PLANNING COMMISSION REGULAR SESSION AGENDA
Monday, October 14, 2024 - 7:00 PM
Council Chambers, 169 SW Coast Hwy, Newport, Oregon 97365

The agenda may be amended during the meeting to add or delete items, change the order of agenda items, or discuss any other business deemed necessary at the time of the meeting.

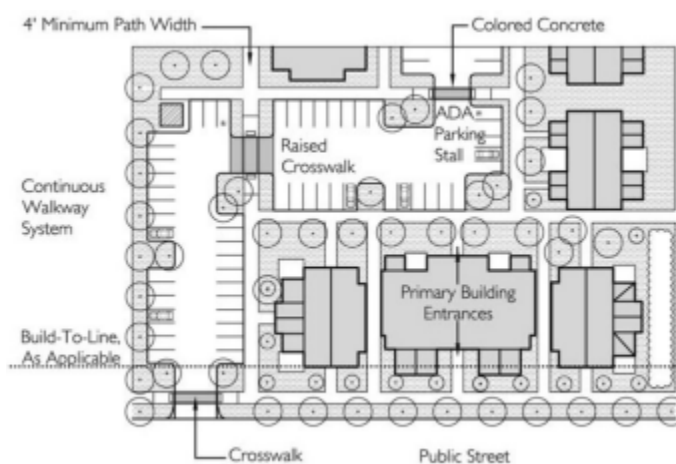
Response: Responses to the standards outlined in Section 14.44.60 are addressed earlier in this narrative.
